**RE: Sundance Construction – Beverly Hills
Grading and Drainage Plan
Engineer's Stamp Date: 02/20/18
Hydrology File: B18D023**

**RE: Sundance Construction -Beverly Hills
Grading and Drainage Plan
Engineer's Stamp Date: 01124/18
Hydrology File: 818D023**

This letter is in response to your comments by letter dated January 30, 2018. The comments have been addressed as follows:

C-101

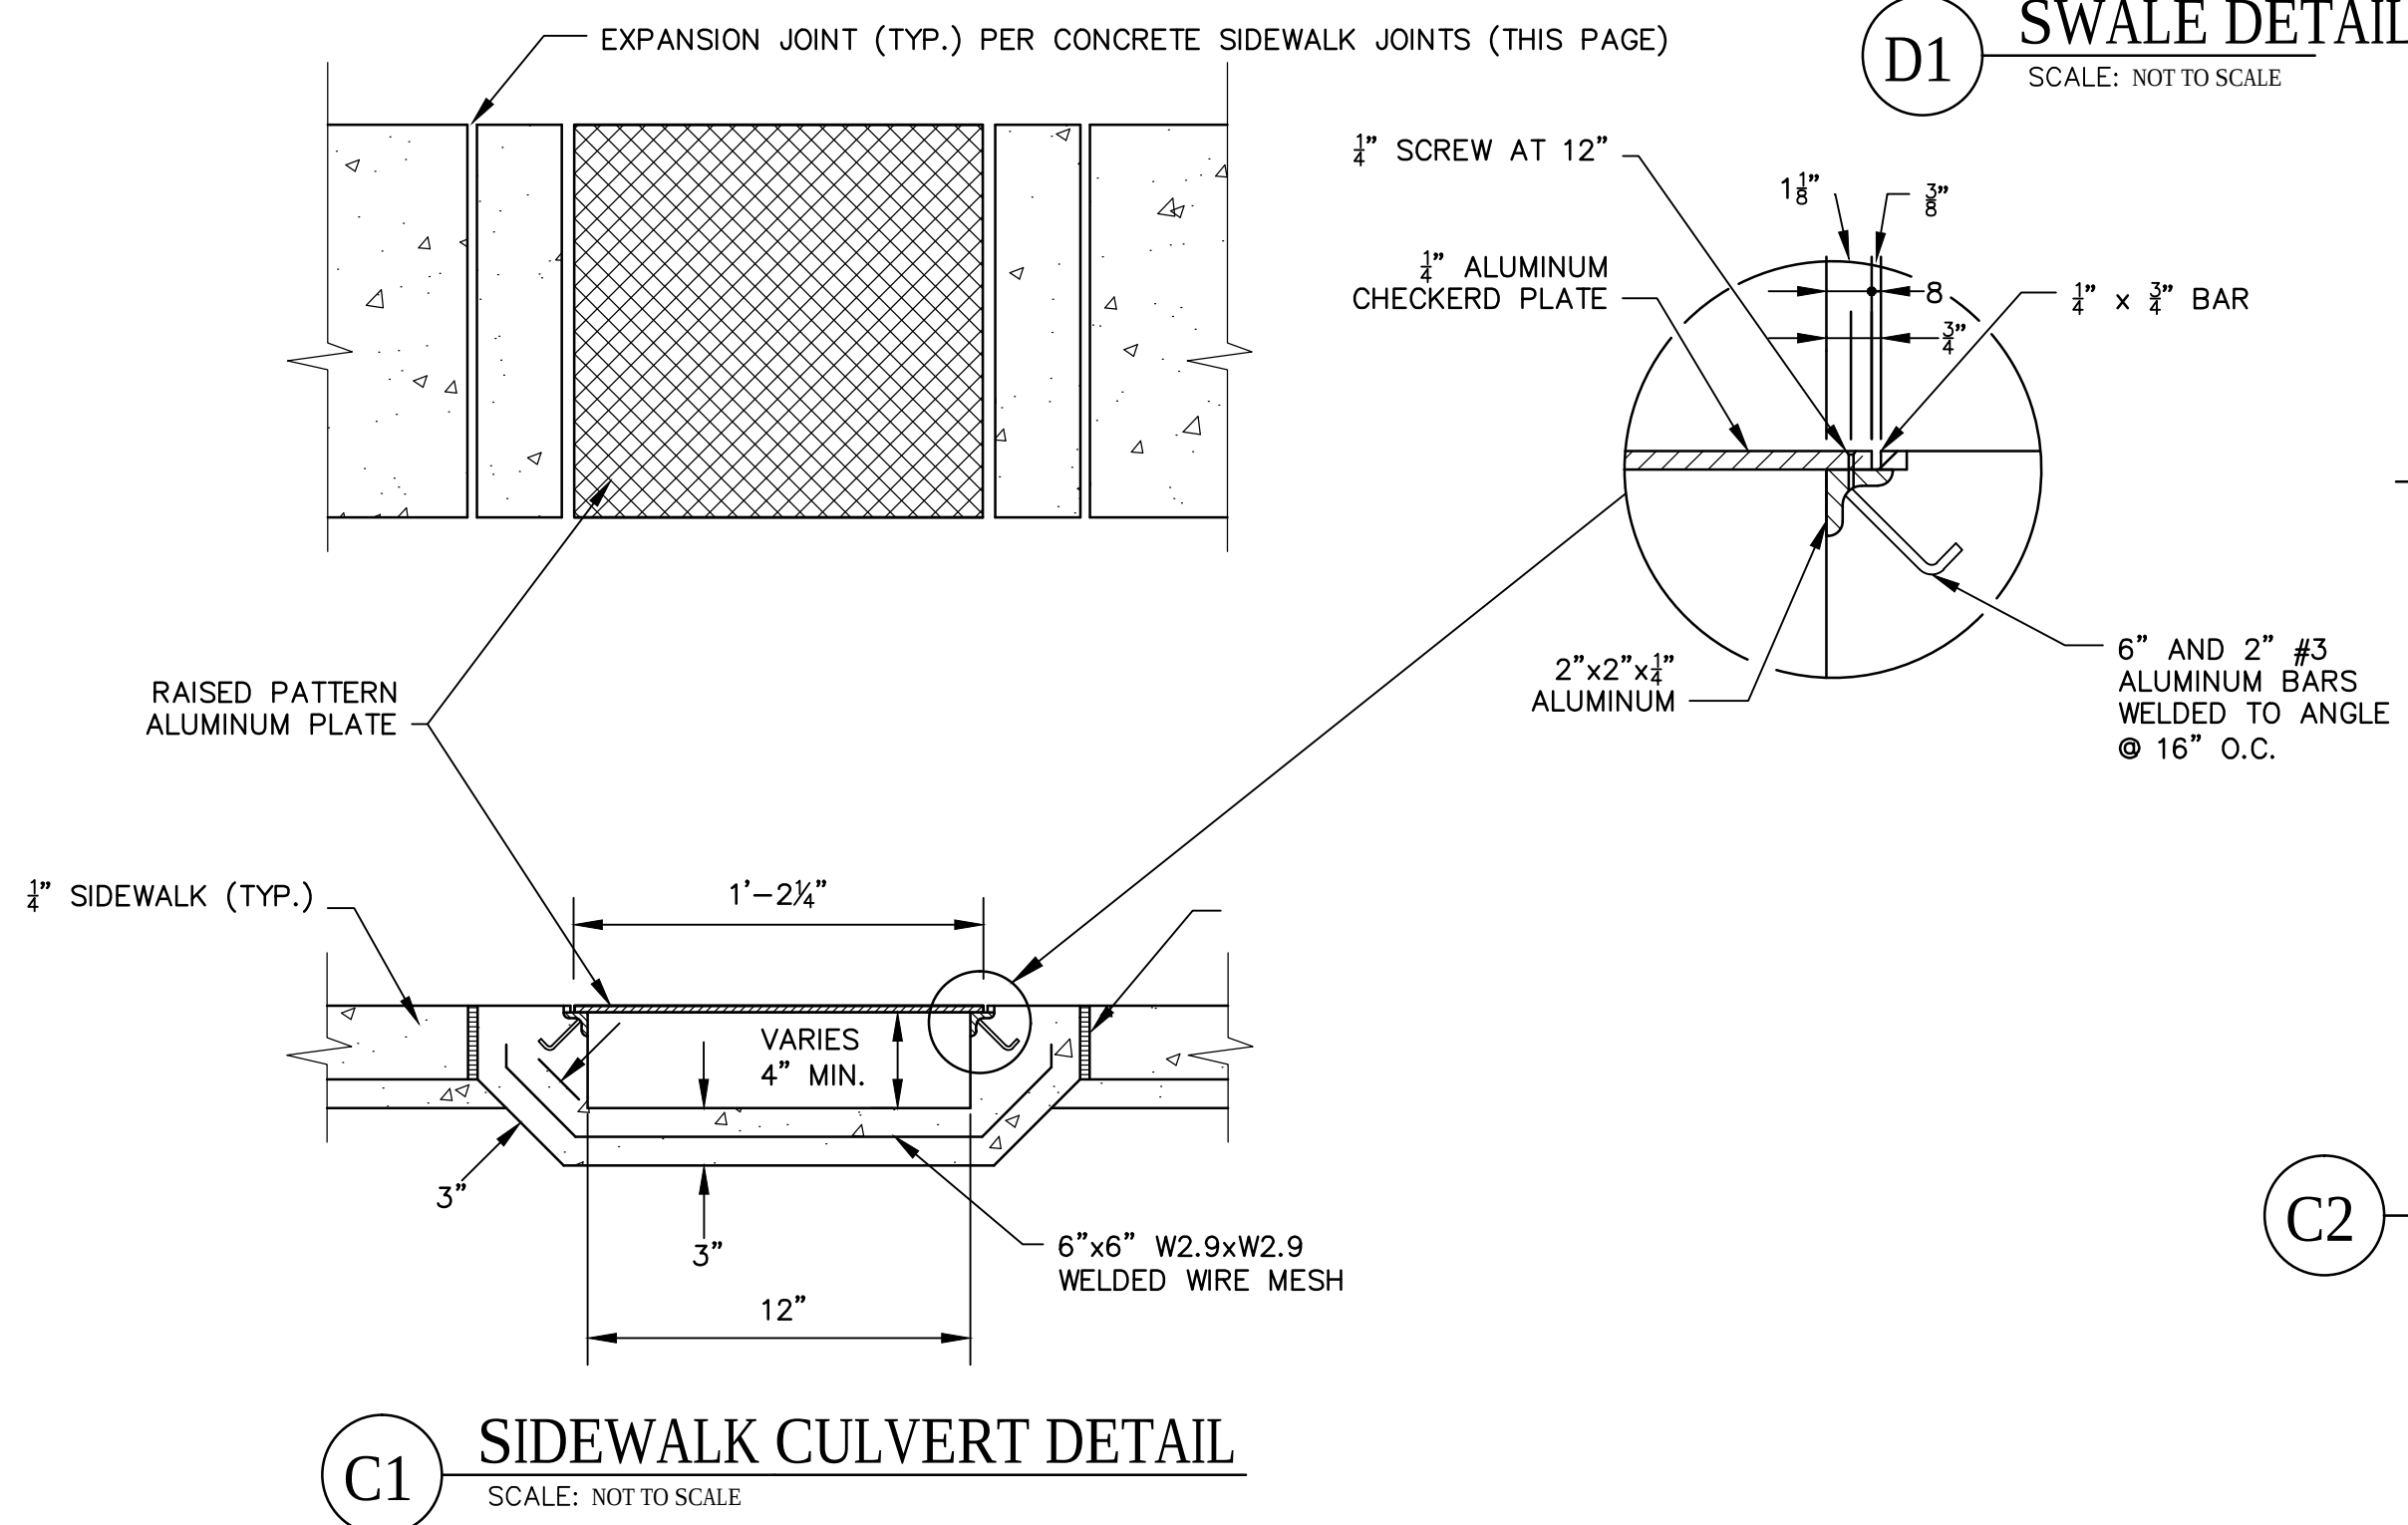
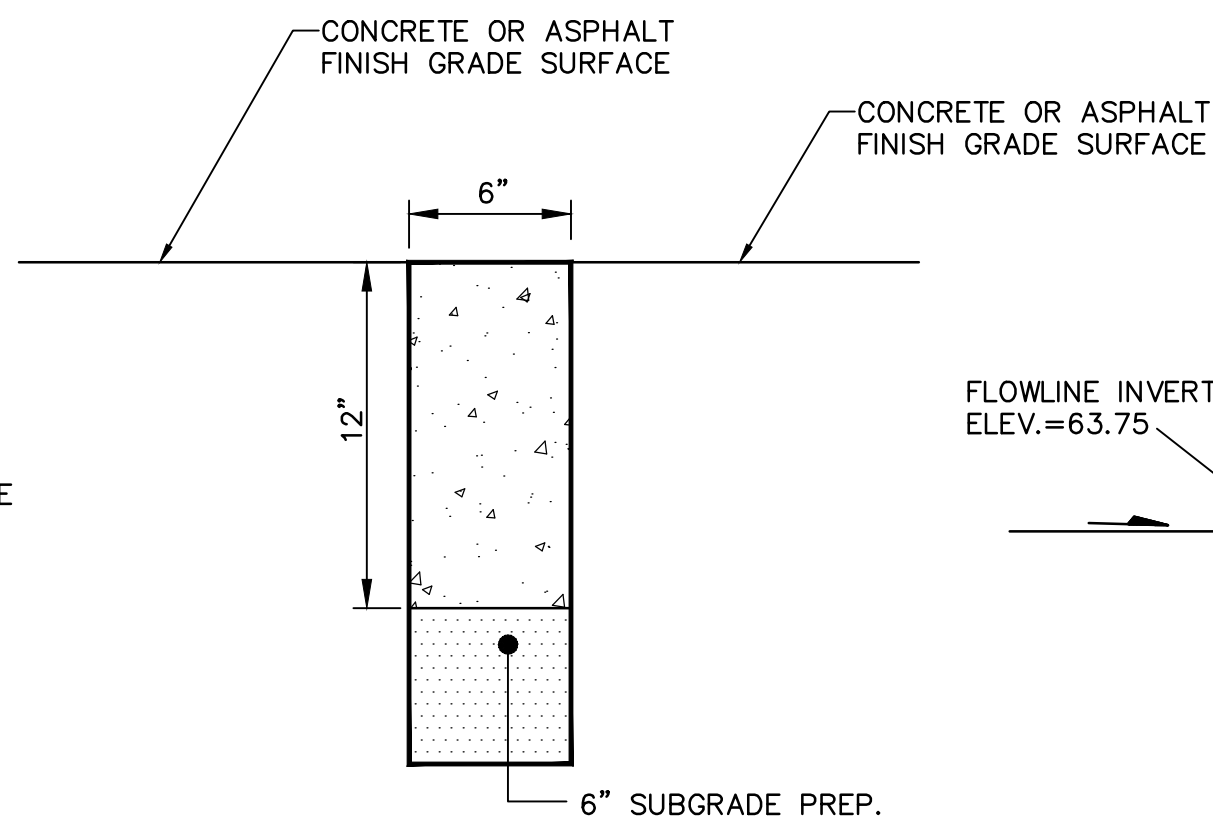
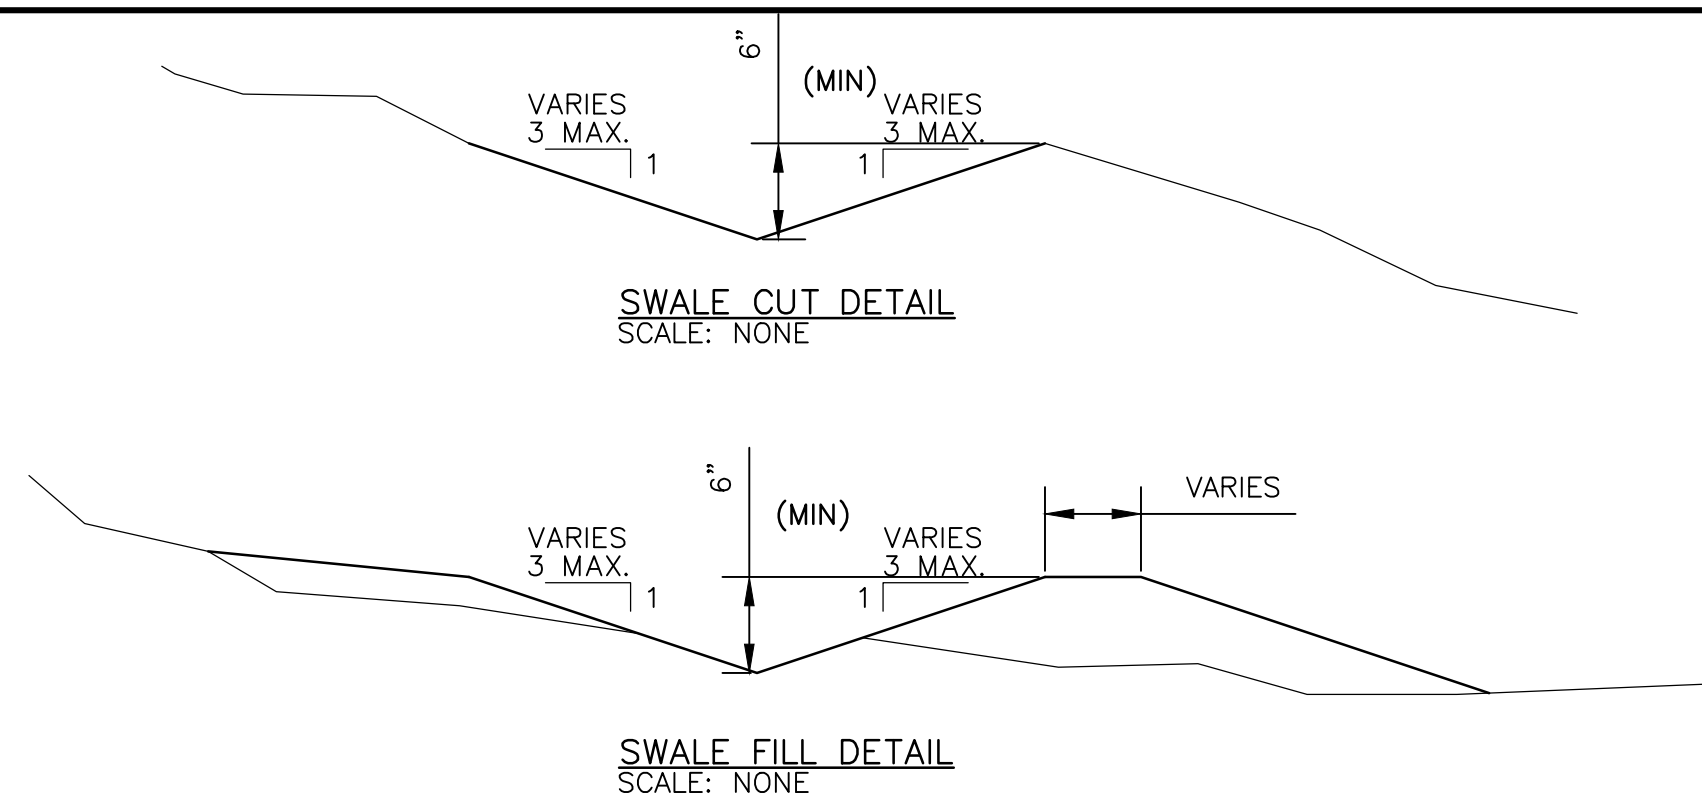
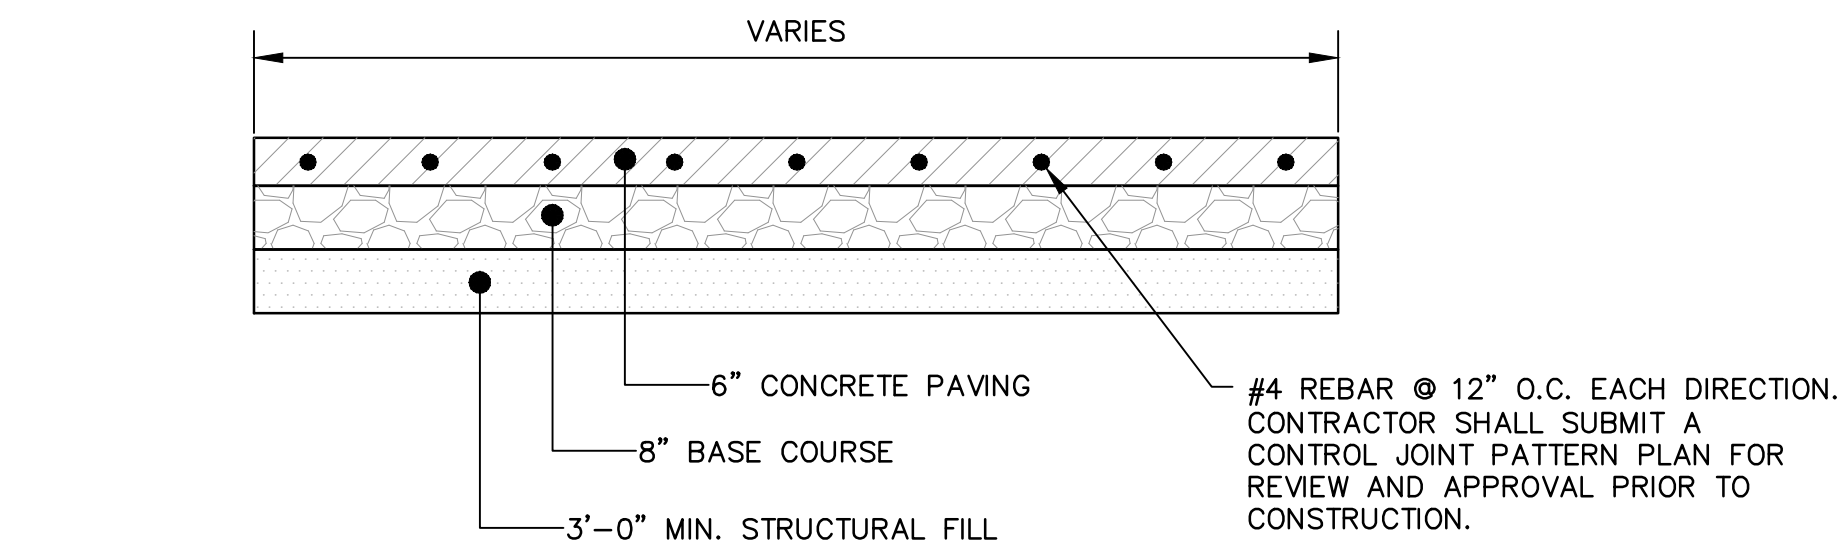
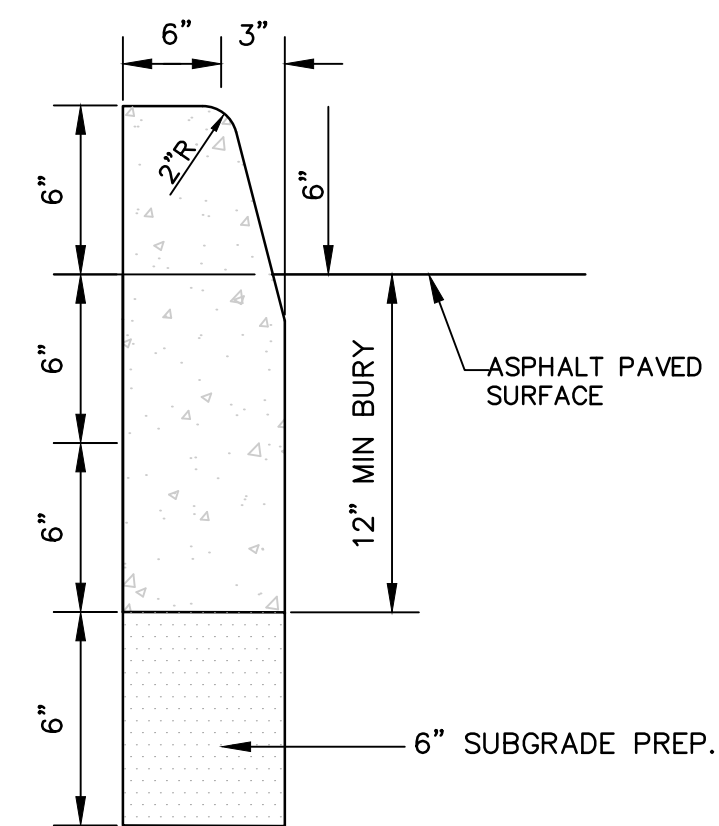
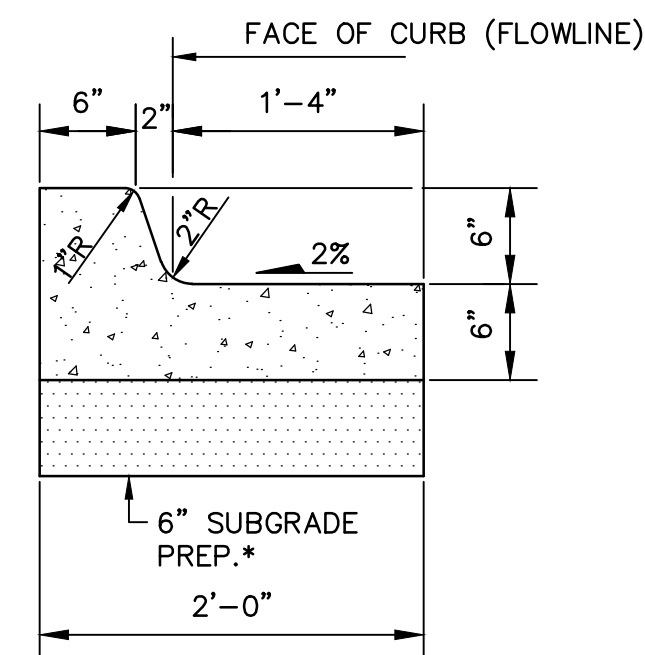
2. Key Note 7 states approximate location of property line. All property lines and existing topographic survey information must be accurate and not approximated. At the northwest corner, it appears that the adjacent pond is on this property. Please submit a surveyed property. If the property lines are properly surveyed, then delete the word approximate location of property line from Key Note 7.

3. Please provide a written agreement from Lot 28 property Owner stating that grading can be conducted on their property for the benefit of Lot 29. If an agreement cannot be obtained, then the swale to divert off-site drainage to Beverly Hills will have to be within the project's boundary.

4. Please add the flowline information at the start of the diversion swale at the east side of the property.

5. Key Note 22. This pond is just pointing to an open area. Is there supposed to be a first flush pond here?? It appears that all first flush volume is included in the pond to the southwest corner of the property.

6. Section A-A. Please show the property line and dimension of the wall from the property line.

7. Section A-A. Per DPM Ch. 22.5.B, grading and construction of retaining walls at or near the property line must demonstrate that the adjacent property is not damaged or its use constrained. Any such encroachment by the wall or grading must be accompanied by written permission of both landowners. Therefore the wall may have to be moved away so that the footer does not impede the adjacent property.

8. Please show the half street, storm drain, and inlet which is to be constructed with the work order. Please add a note that all work within Beverly Hills Ave will be part of Work Order #722084.

See sheet C-101.

IN PROCESS.

See sheet C-101.

See sheet C-101.

See sheet C-101.

Added some notes for clarity. See sheet C-101.

See sheet C-101.
